ADDENDUM NO. 1

Roof Replacement

Shakespeare Theater Building
Shakespeare Festival Theatre
Stratford, Connecticut

Architects Project No. 0903.01

02/28/09
 Job #: 0903.00
 SK2.28.09-1

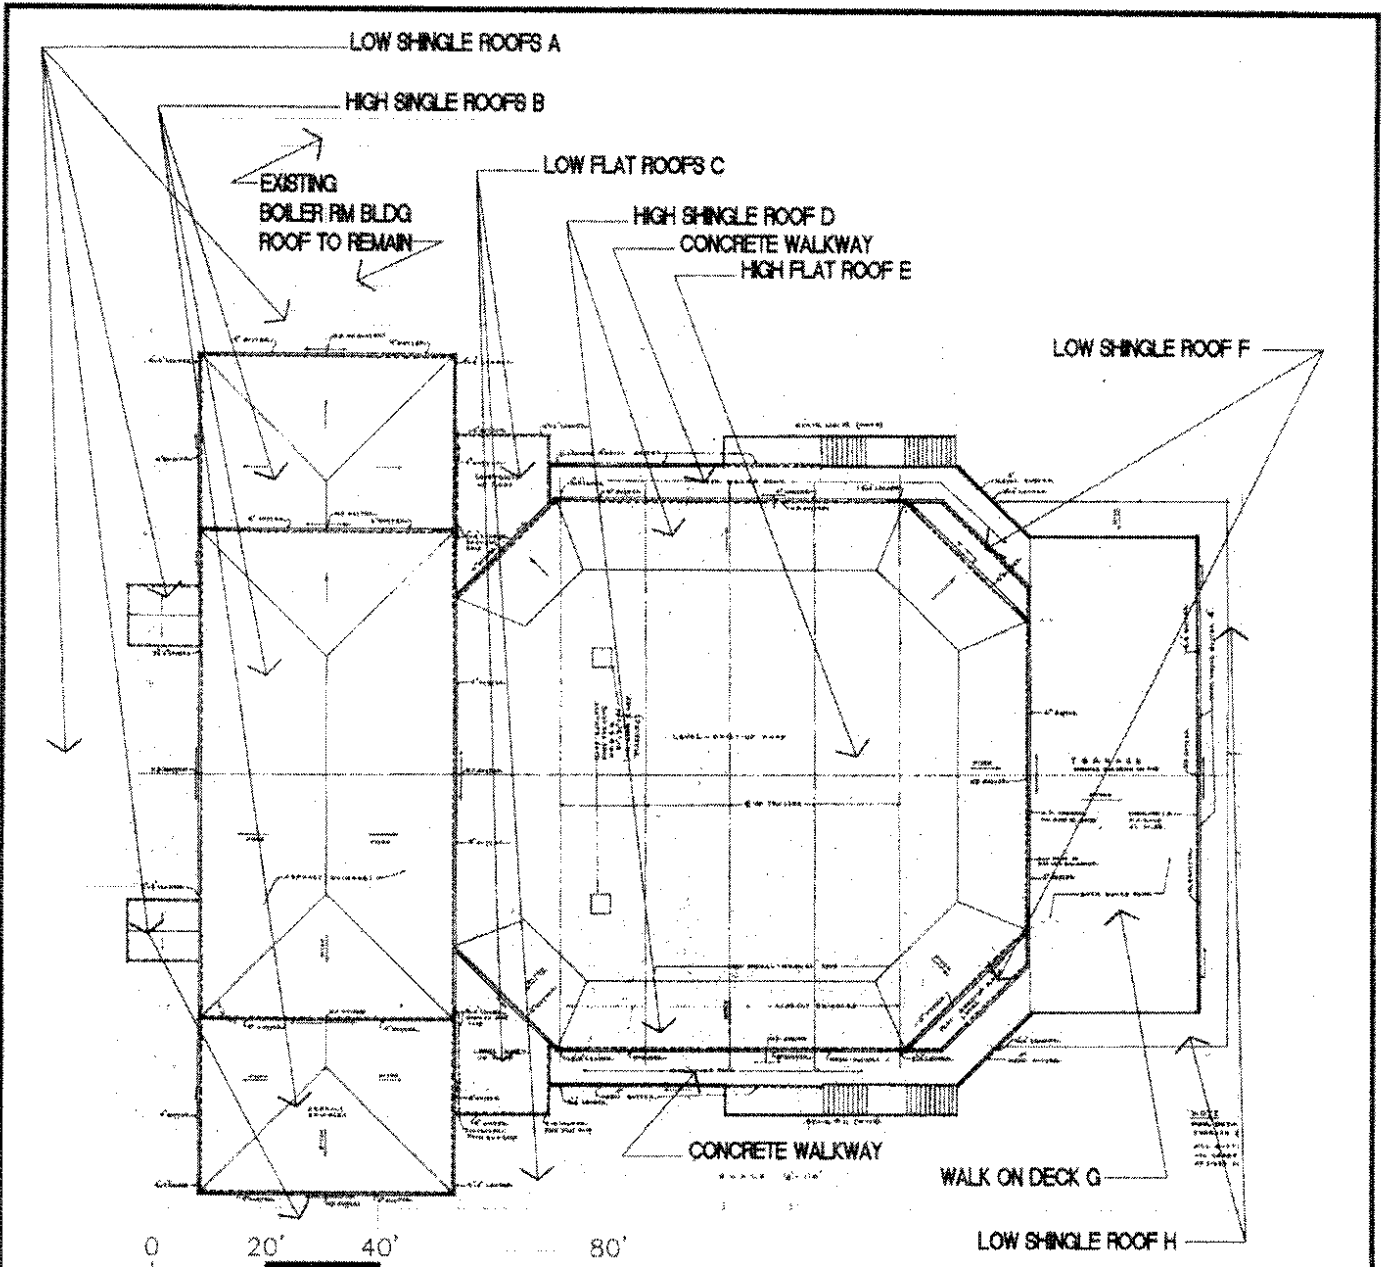
9. The project scope does not include the replacement of the roof and repair of the masonry chimney on the Mechanical Equipment Building adjacent to the east elevation of the Theater building. All other roof areas are to be replaced, refer to attached sketch SK2.28.09-1 for roof area locations, roof type and area or roof to be replaced to be used for the purposes of bidding.

THE ROOF & DECK AREAS LISTED ABOVE ARE FOR THE PURPOSES OF BIDDING ONLY TO ESTABLISH PROJECT SCOPE. AREAS SHOWN ARE APPROX. AND BASED ON THE AVAILABLE DRAWINGS PROVIDED BY THE TOWN OF STRATFORD.
